The design and prototyping process for creating accessible door accessories has primarily been testing existing models found online and interviewing some users in one of our target demographics to understand their likes and dislikes of the existing solutions.

Feedback grid from interview 2:

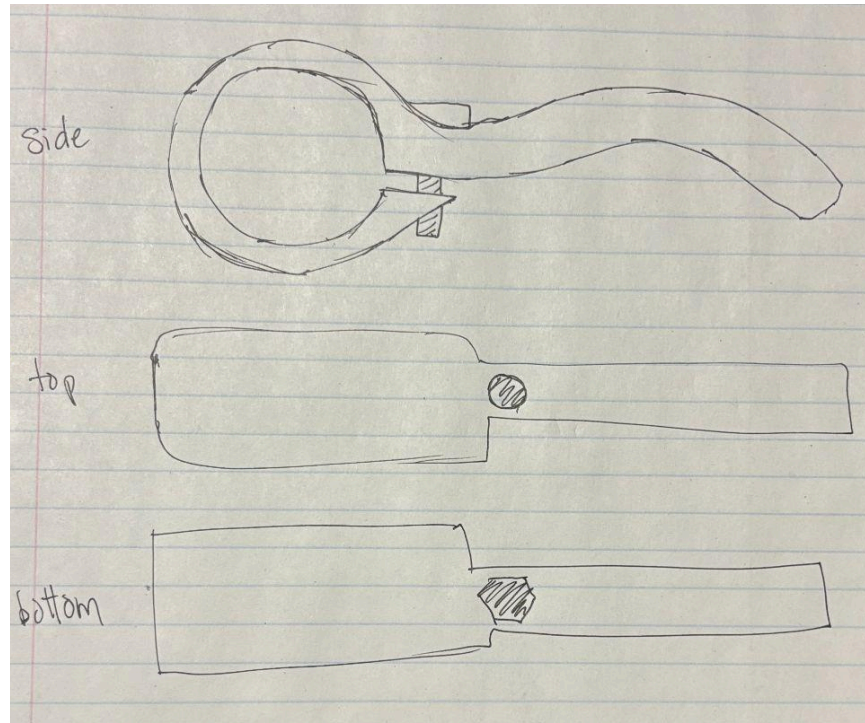
Likes <ul style="list-style-type: none">- Feels way more solid- I feel like i'm not gonna break it off- Ergonomic curve of the handle	Criticisms <ul style="list-style-type: none">- When pulling it feels like your hand can just slide out on accident
Questions <ul style="list-style-type: none">- What infill is this?	Ideas <ul style="list-style-type: none">- L shape on the end to grip better
